ACCESSIBILITY REPORT

11 LEWIS STREET, BALGOWLAH HEIGHTS NSW 2093

CLASS 9B EARLY CHILDHOOD CENTRE AND BASEMENT CARPARK

Prepared for:	Oxford Number 1 Pty Ltd
Description:	<p>To satisfy Northern Beaches Council DA lodgement requirements, undertake a desktop review of the development application plans against the accessibility provisions* of the National Construction Code (NCC) 2019 amendment 1.</p> <p>* NCC parts D3, E3.6, F2.4 and G6.7.</p>
Report number:	200154r1.0_Access
Date:	21.12.2020

Public domain and basement car park

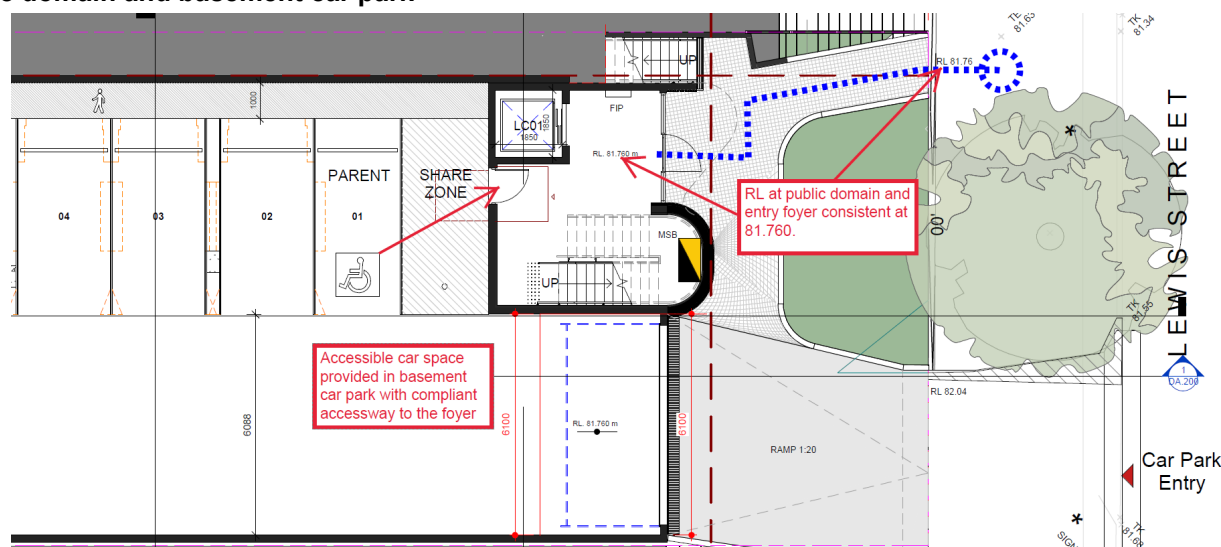
D3.2	Access to Buildings	Complies	<p>The principal pedestrian entry via Lewis Street is provided with compliant accessible entry in accordance with AS1428.1-2009.</p> <p>Accessway from accessible car parking space – Compliant accessway provided from the accessible car parking space.</p>

Car park entry

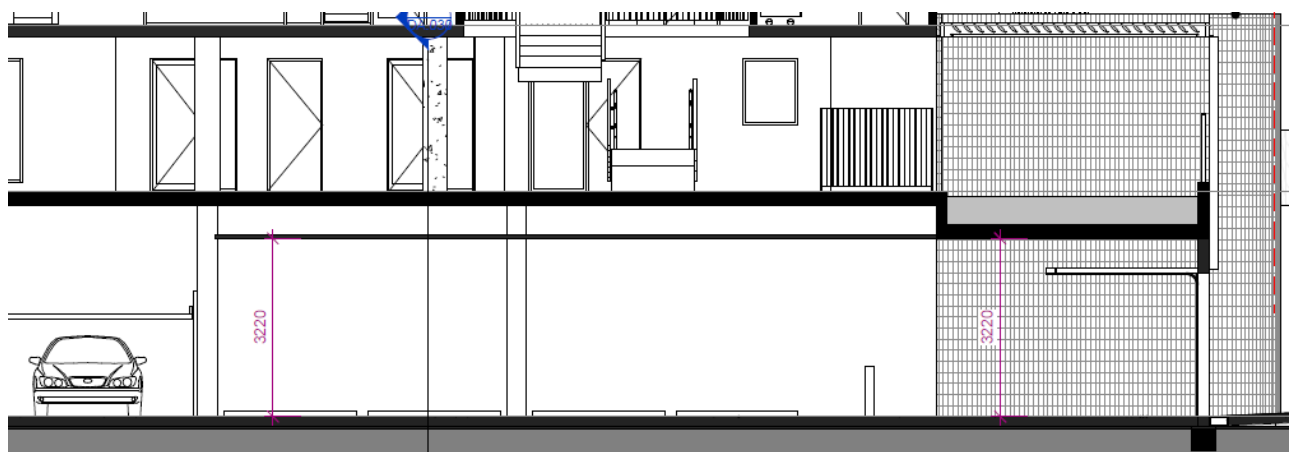
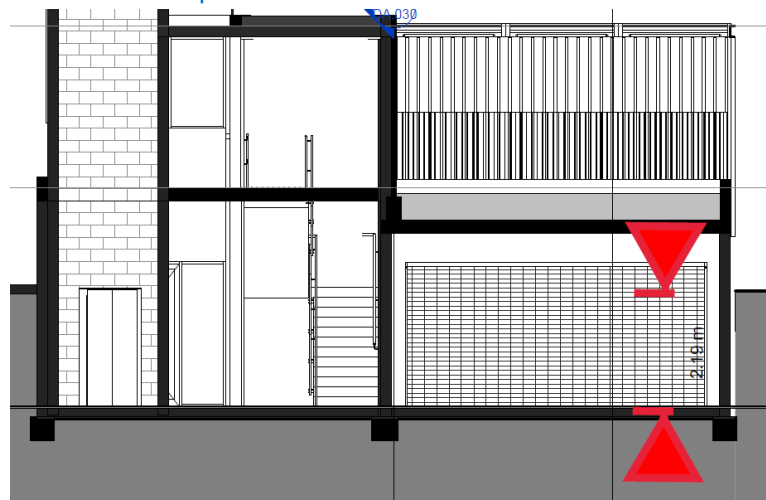
The roller door drum has not been dimensioned however there appears to be sufficient room to accommodate the minimum 2200mm head room height for accessibility purposes. A height of 3200mm from the finished floor level has been provided above the accessible car space.

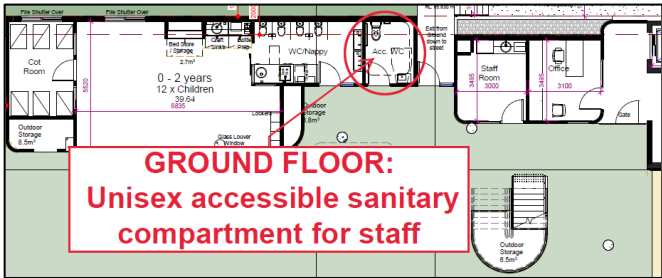
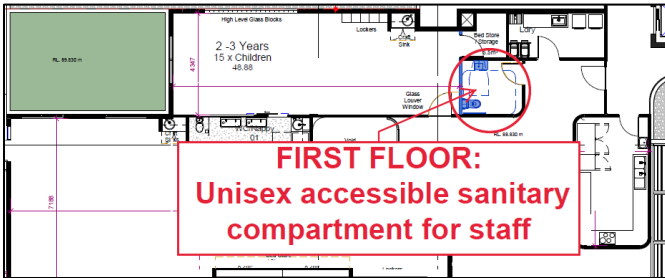
SECTION F – HEALTH AND AMENITY			
Clause	Description	Status	Comments
Part F2 – Sanitary and Other Facilities			
F2.4	Accessible sanitary Facilities	CRA	<p>An accessible unisex sanitary compartment has been proposed for staff on ground floor and level one. These are to incorporate one left-handed, and one right-handed facility.</p>

Clause	Description	Status	Comments
			<p>It is noted that staff and children are not permitted to share sanitary facilities in an early childhood centre, however where a child in a wheelchair is enrolled, an appropriate operational management plan must be in place and signed off by all relevant stakeholders including the parents or guardians of the child, to permit that child to use the accessible sanitary facility.</p> <p>Ambulant cubicles have not been proposed. There is no requirement for this as there are no additional toilets at any of the staff banks of toilets.</p> <p>Full compliance with AS1428.1:2009 is to be indicated on the Construction Certificate Plans submitted to the certifying authority.</p>
<p>Accessible facilities on ground floor and level one must alternate left-hand and right-hand transfer.</p> <div>  <p>GROUND FLOOR: Unisex accessible sanitary compartment for staff</p> </div> <div>  <p>FIRST FLOOR: Unisex accessible sanitary compartment for staff</p> </div>
